**Maxum II Modular Oven Needle Valve**  
**Product Update**  
PU-001

This document describes the new options and mounting locations for needle valves in the Maxum Modular Oven.

**Figure 1. Needle Valve Location and Components**

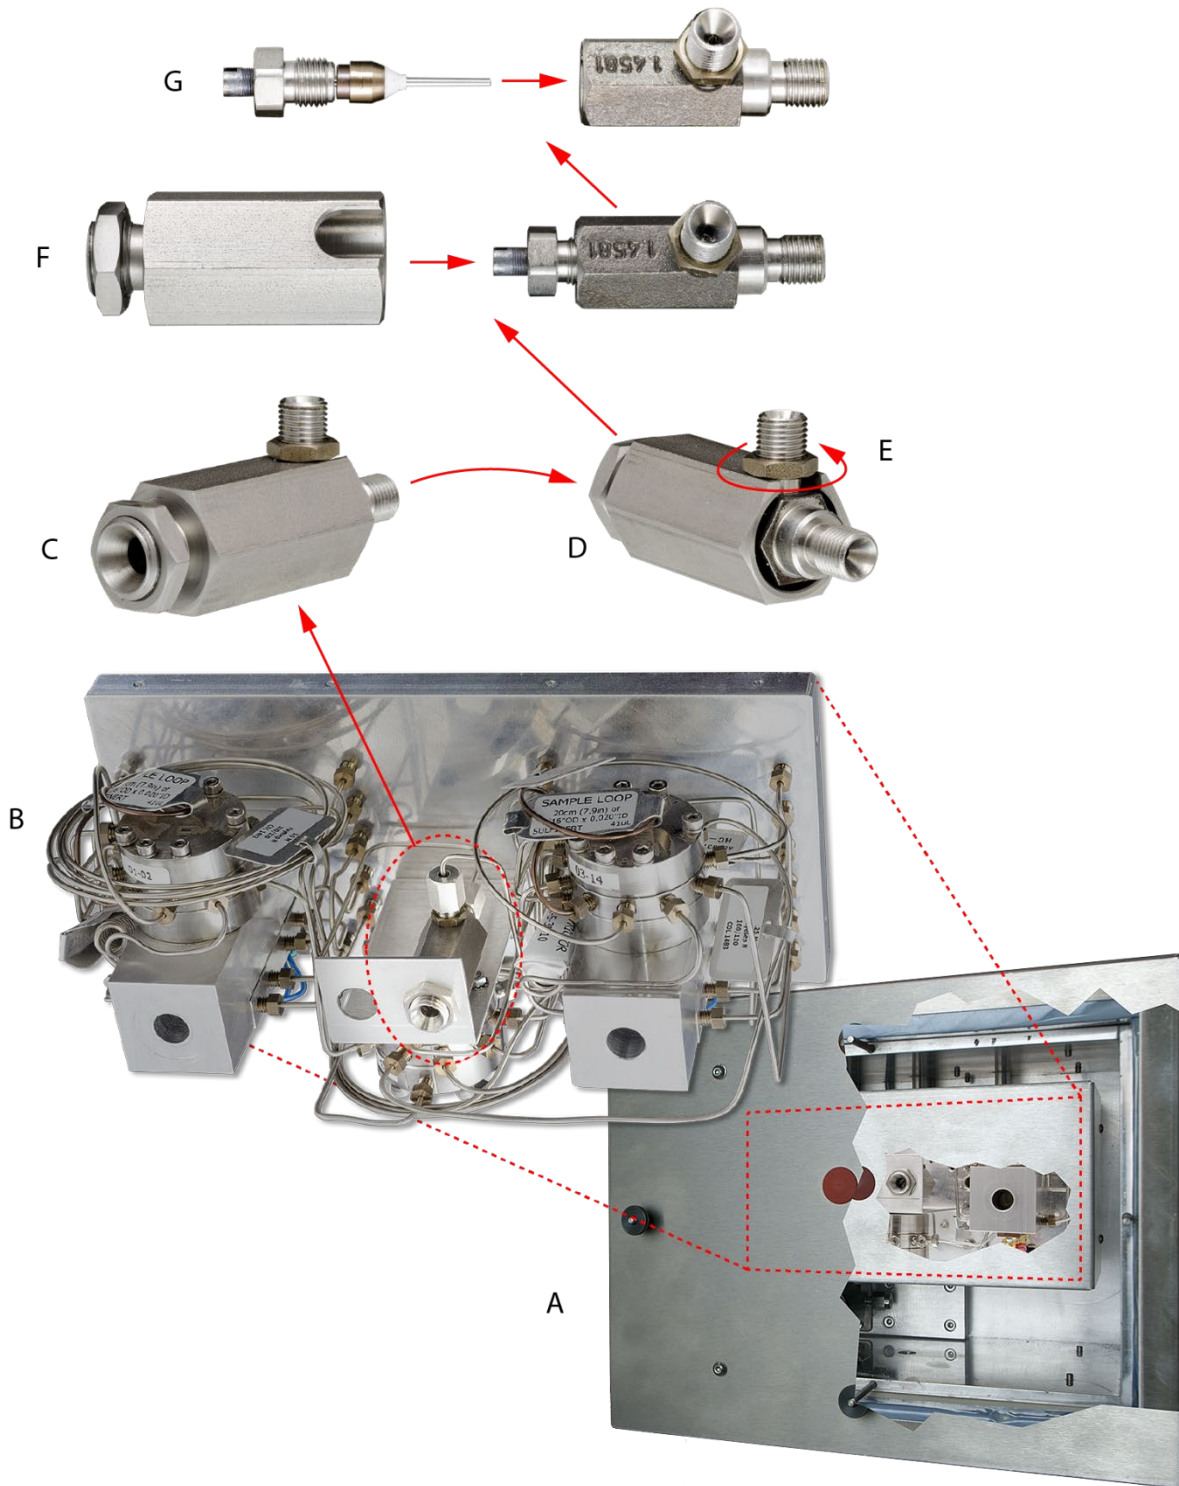
- Inside the Modular Oven Compartment, the door mounts with 4 thumb nuts. (A in Figure 1). The application module cover has two access holes for the needle-valve adjustment ports.
- The dual-detector module can have up to 3 Model 50 valves and 2 needle valves. (B in Figure 1). The needle valves are mounted on a bracket between the two detectors, along with a third Model 50 valve.
- Each needle valve is in a housing held onto the bracket by a single nut that surrounds the adjustment port. (C in Figure 1).
- The needle valve can be removed from the housing by loosening the nut on the radial port and sliding the valve body out. (E and F in Figure 1).
- The adjustment needle can be removed by unscrewing the nut. (G in Figure 1).

**Figure 2. Adjusting the Needle Valve**

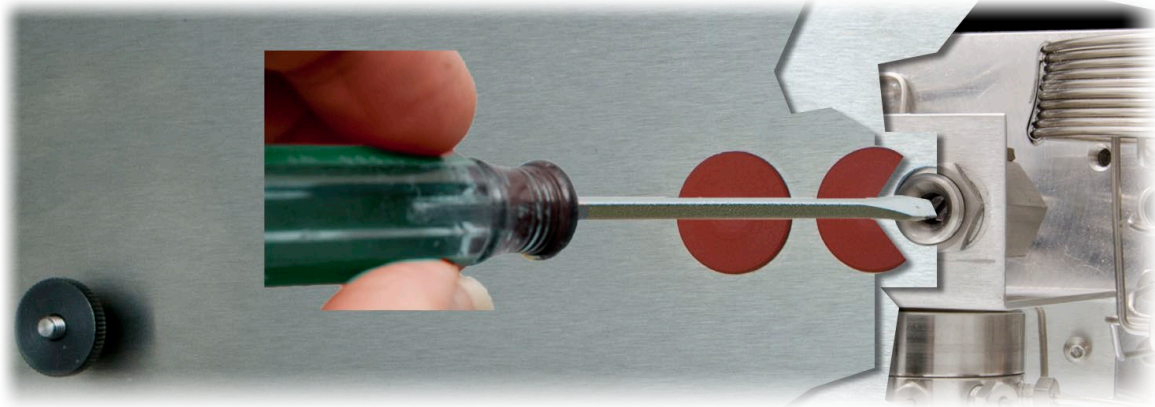
The needle valve can be adjusted without removing the oven door. The rubber plugs in the door have slits to allow a screwdriver to be inserted through to the adjustment port.
